**Total Maximum Daily Loads (TMDLs)
for
Dissolved Oxygen and Iron
in the Waters of
Duck Creek in Mendenhall Valley, Alaska**

**Total Maximum Daily Loads (TMDLs)
for
Dissolved Oxygen and Iron
in the Waters of
Duck Creek in Mendenhall Valley, Alaska**

Appendix F: Response to Public Comments

Figure 8. Validation of simplified model simulation of iron and DO for June 1997

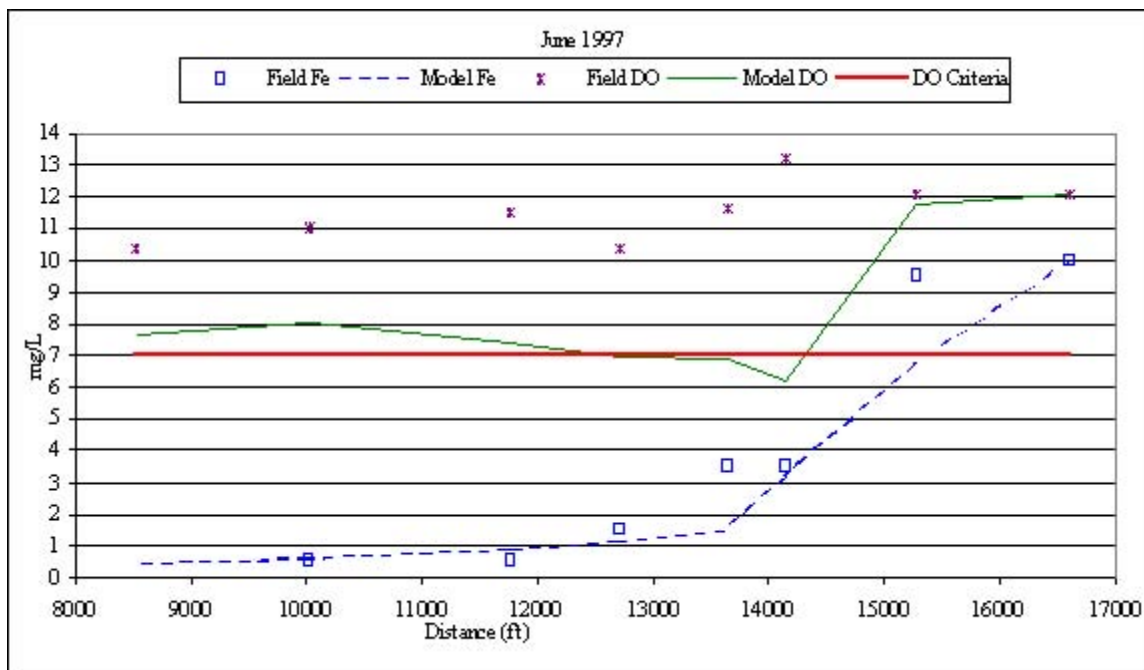
<p>9. Page 20, last sentence of first (incomplete) paragraph: “The predicted values are deemed to be sufficiently accurate given the limited amount of iron data available...” According to figure 8 the predicted values for DO are uniformly lower than the observed data in most cases by large amounts. In particular the model predicts DO levels less than the 7 mg/L minimum allowable, while the observed levels exceed this level by about 50%.</p>	<p>A section entitled “Limitations of the Iron and Dissolved Oxygen Model” has been added to the TMDL and describes the model in more detail. The available data allowed only a very simplified modeling approach. The observed DO values in figure 8 represent supersaturated conditions. In order to simulate supersaturation, the model would have had to include a simulation of algae. Sufficient data were not available to support such a detailed modeling approach. As a result, the model could not simulate the supersaturated DO values seen in Figure 8. However, the model simulates iron and non-supersaturated DO observations well, as seen in Figures D-1 and D-2.</p>

Figure D-1. Calibration of simplified model simulation of iron and DO for August 1995

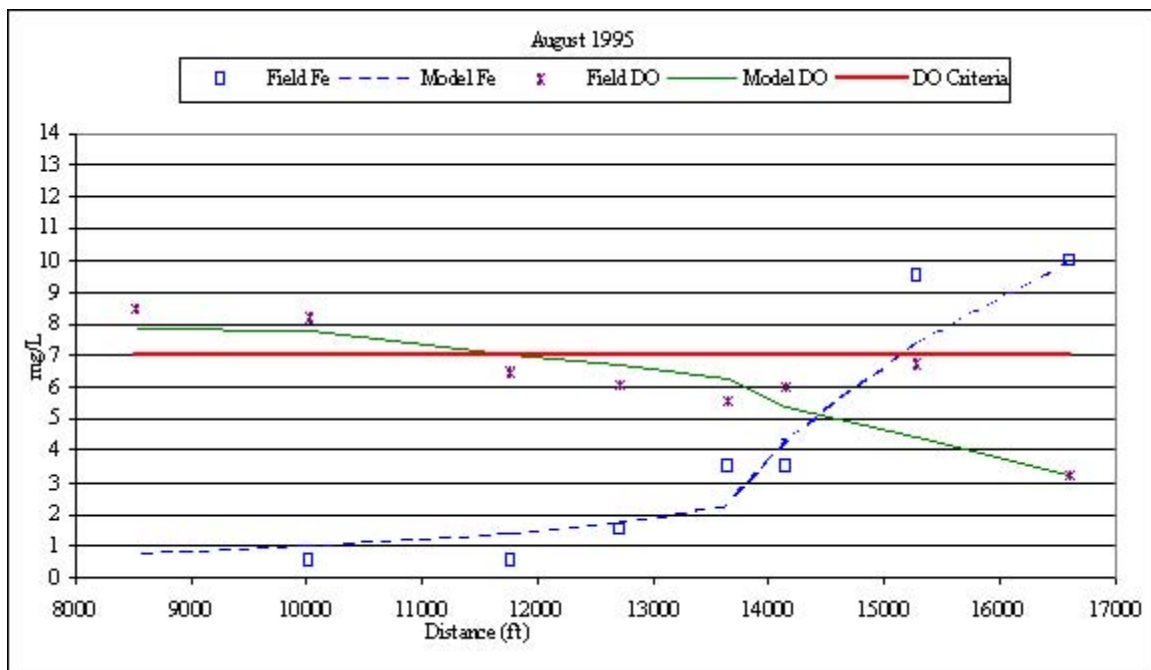
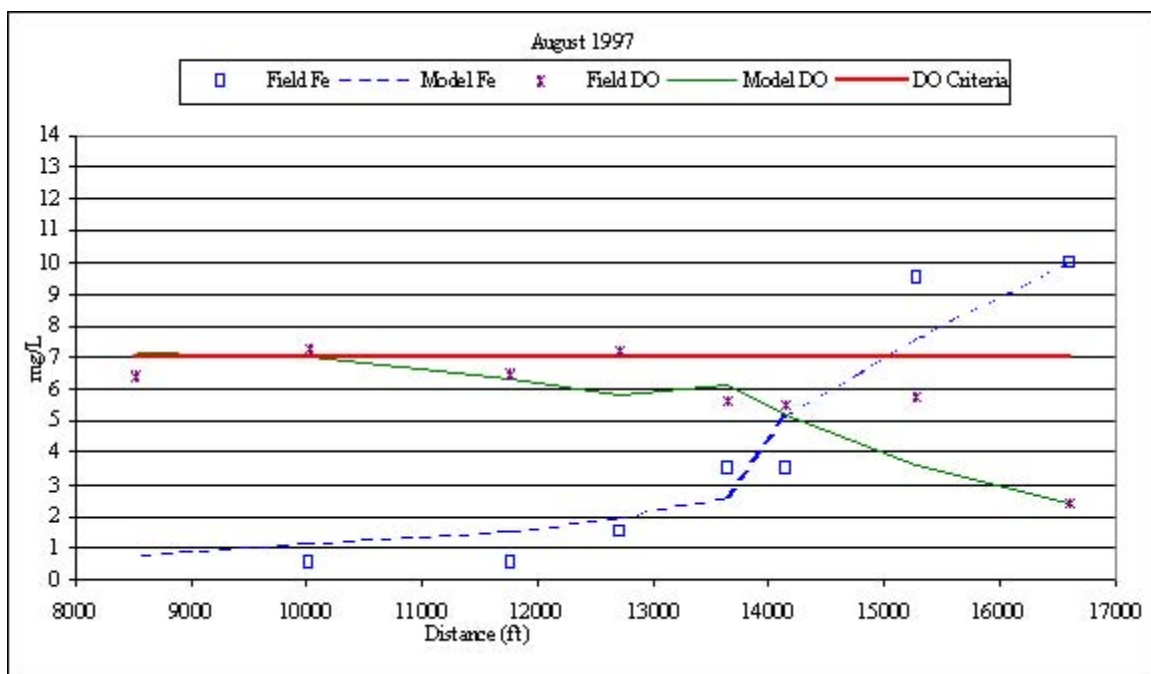
Comment	Response
<p>11. Page 22, second paragraph: “The accuracy of this simplified model analysis is estimated at 0.1 mg/L.” None of the charts comparing the model’s output to actual measured conditions come close to having this degree of accuracy. The model is off by several mg/L in figure 8, approximately 1 mg/L in Figure D-2 and even in the calibration trial Figure D-1, the predictions are more than 0.1 mg/L from the field measurement at half of the stations. If the model actually did predict DO to within 0.1 mg/L it would be a useful tool indeed, but if Figure D-2 (or Figure 8) is representative, it’s usefulness at this time is questionable.</p>	<p>A section entitled “Limitations of the Iron and Dissolved Oxygen Model” has been added to the TMDL and describes the model in more detail. The assumption of iron following an exponential decay creates an error in the DO that can not be precisely quantified. The accuracy of the model equations is estimated at 0.1 mg/L. However, uncertainty associated with reaction rates and other variables means that the error is likely larger. The model is believed to simulate the system as accurately as possible with the available information. The use of first order reaction rates represents a conservative assumption that accounts for some of the model error. First order rates could overestimate the uptake of iron and overpredict the oxygen demand.</p>
